1728 Fortis South Steyne

34-35 South Steyne Manly NSW

TITLE	GA Elevation North & South Elevations
-------	--

GA Sections Section AA, BB & EE

1:100

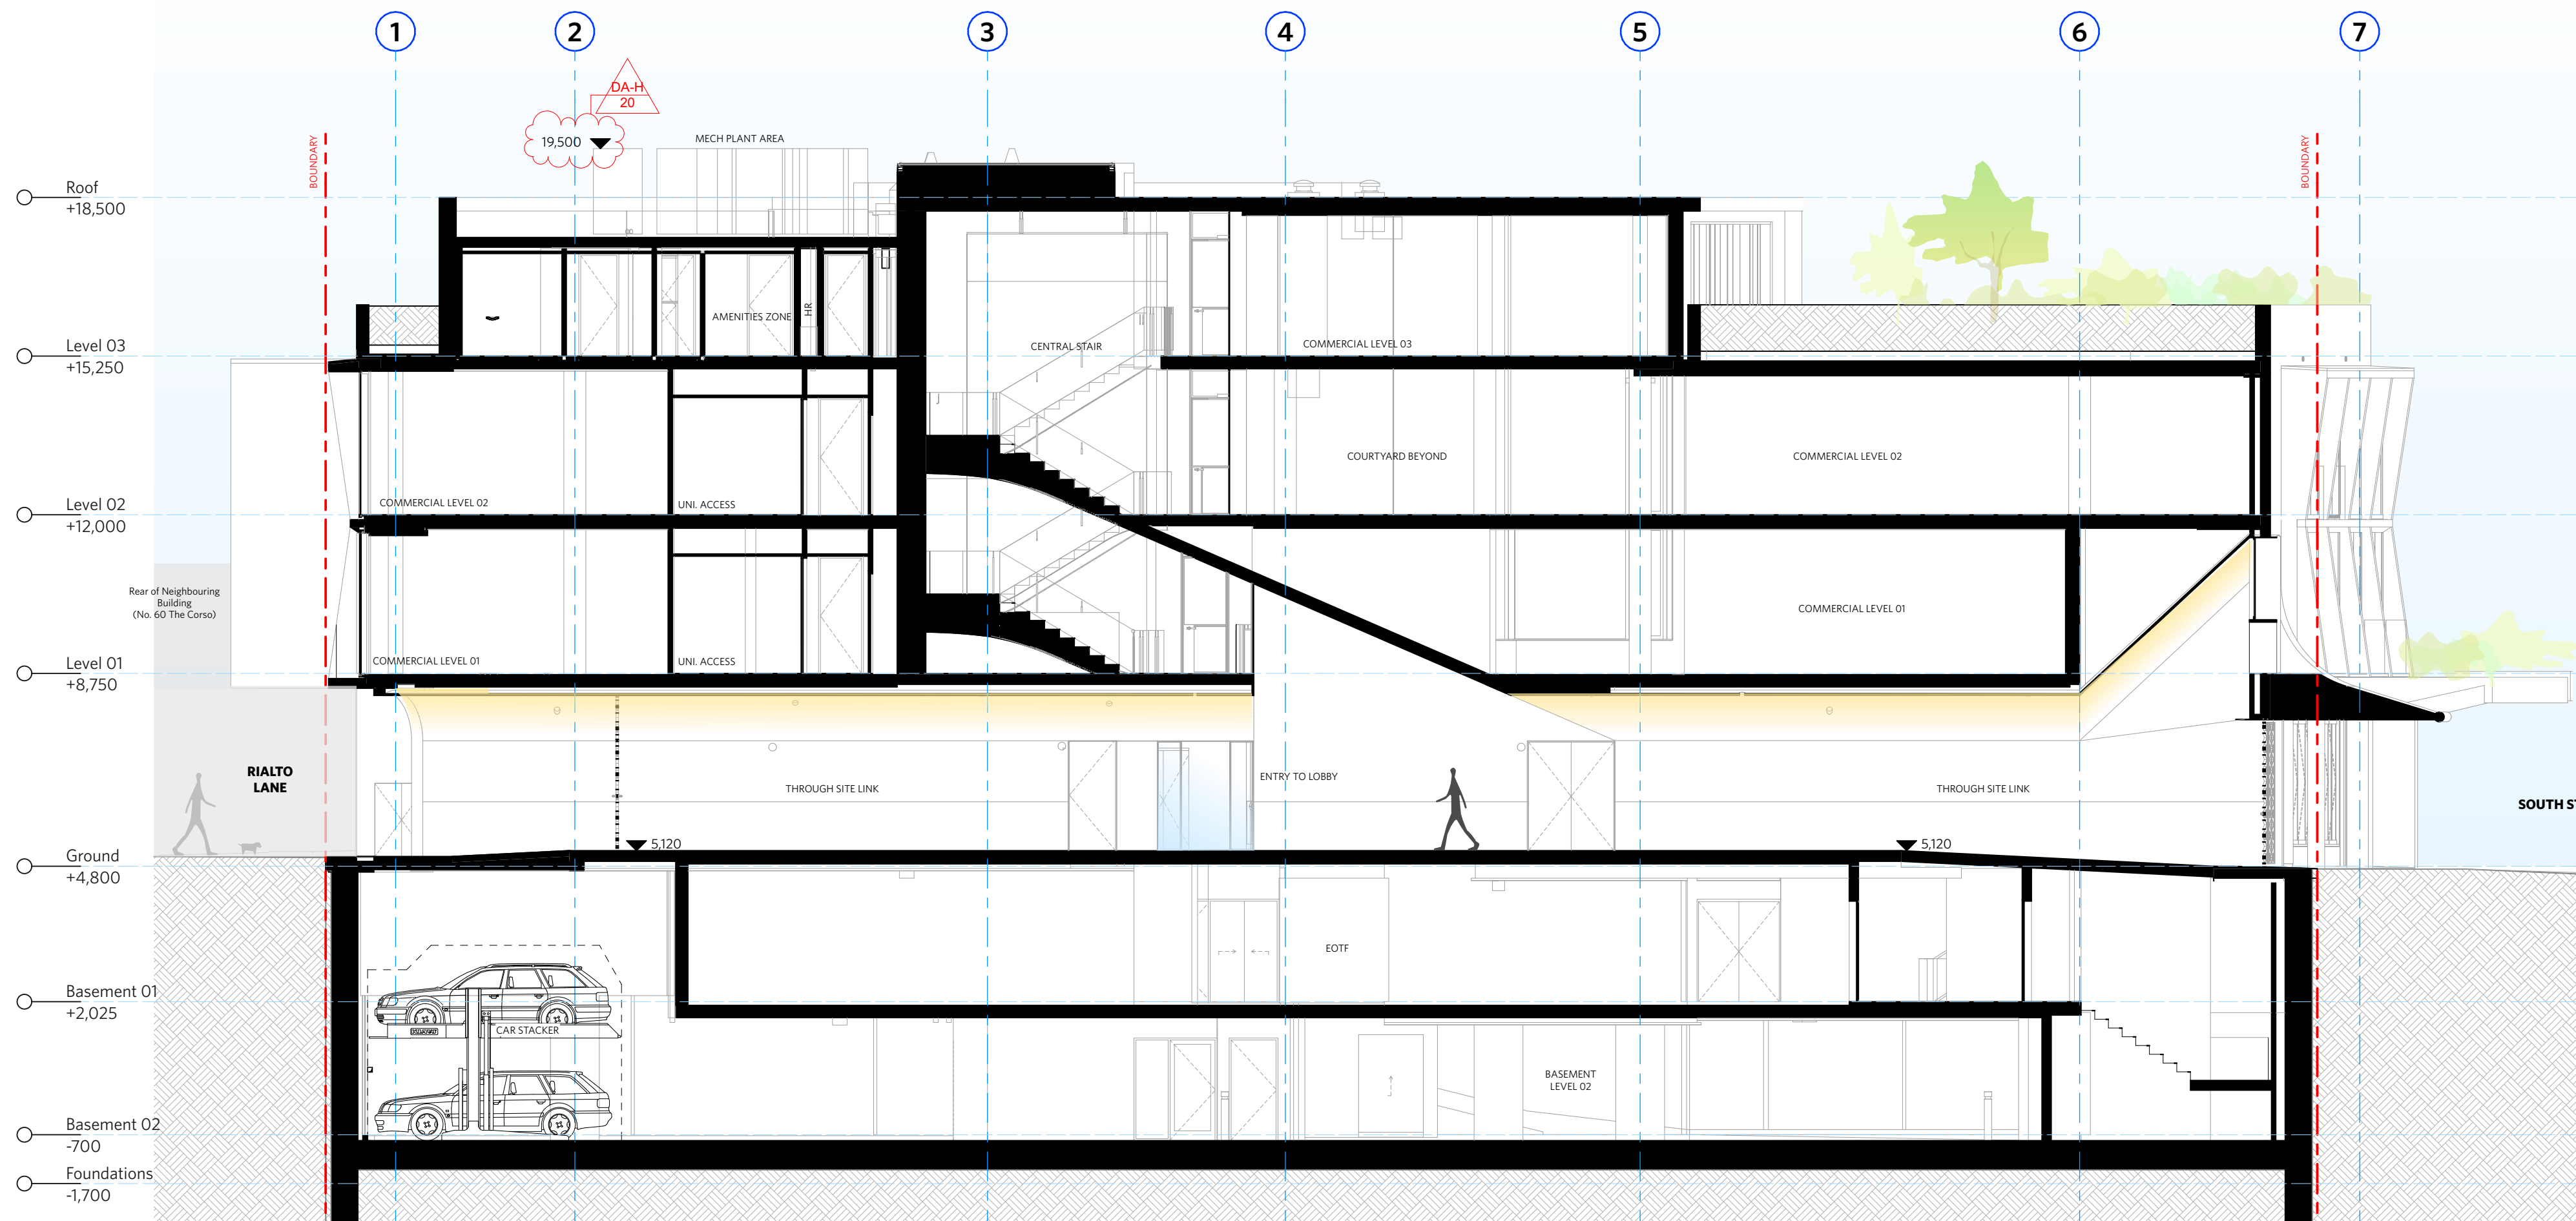
REV	CHANGE	DESCRIPTION
DA-H	20	RL Added for Mechanical Plant

PROJECT NO.	ISSUE	REV.
1728	DA	DA-H
DRAWING NO.		
A-DA-310-002

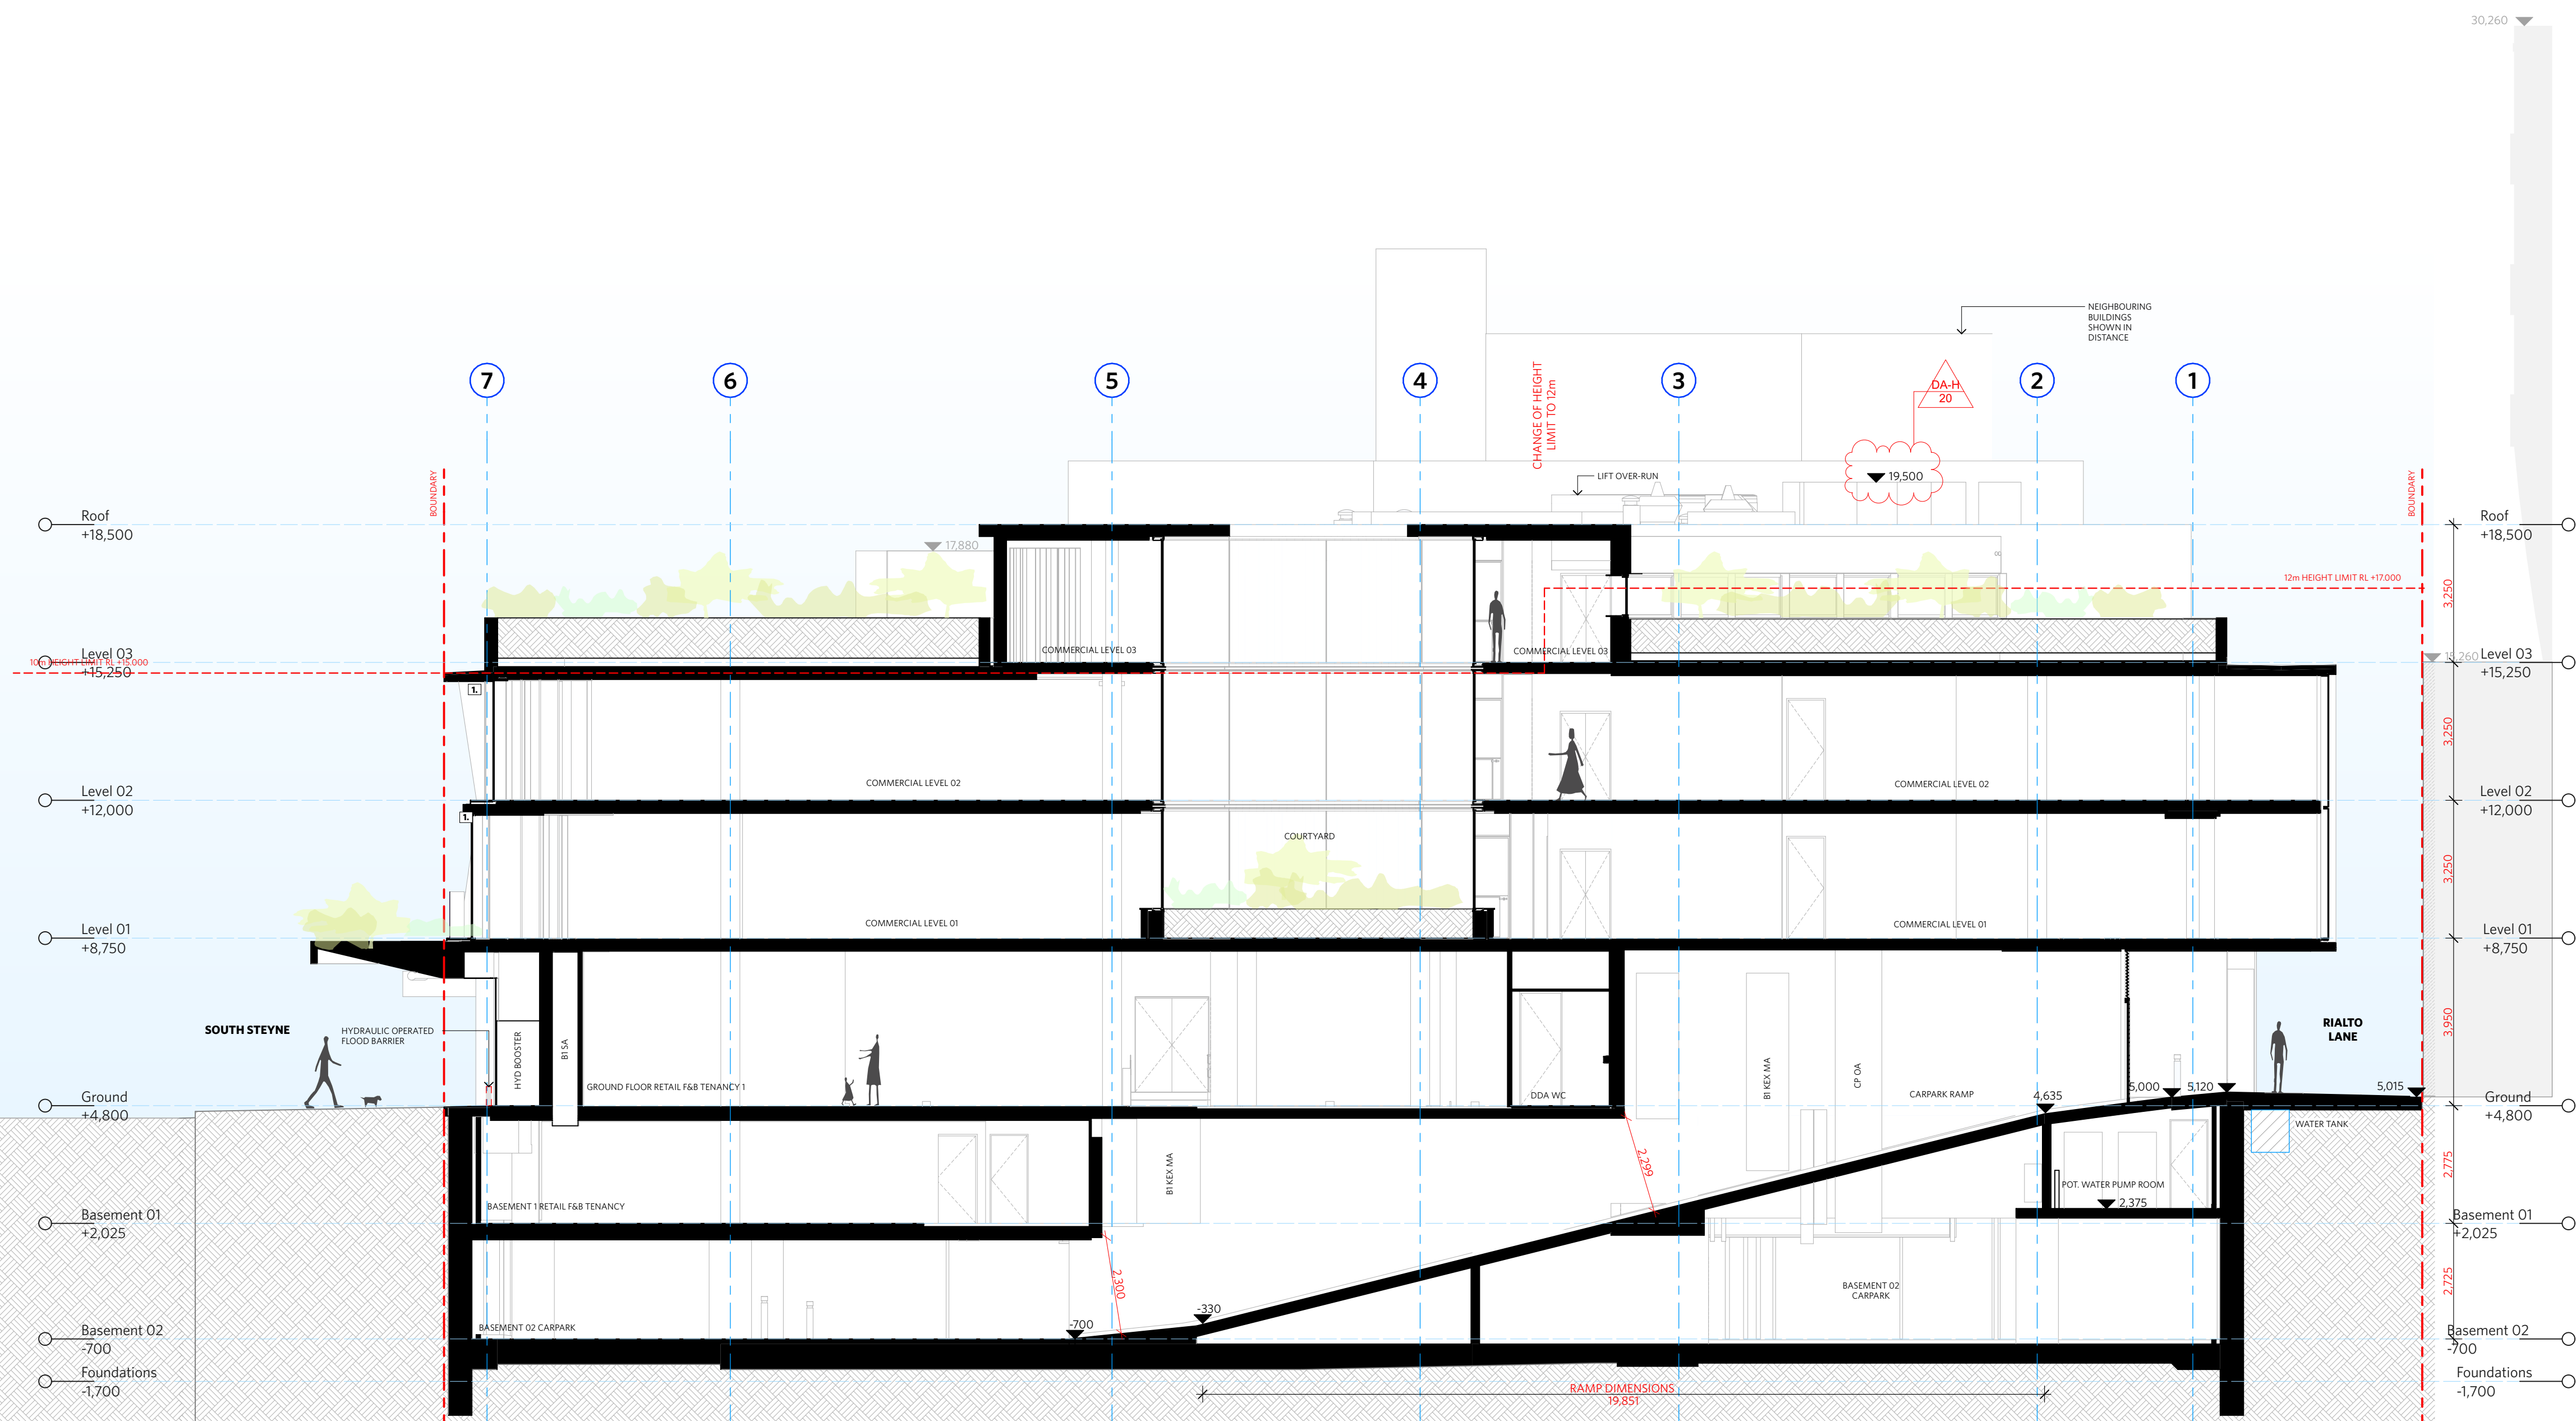
REV	CHANGE	DESCRIPTION
DA-H	20	RL Added for Mechanical Plant
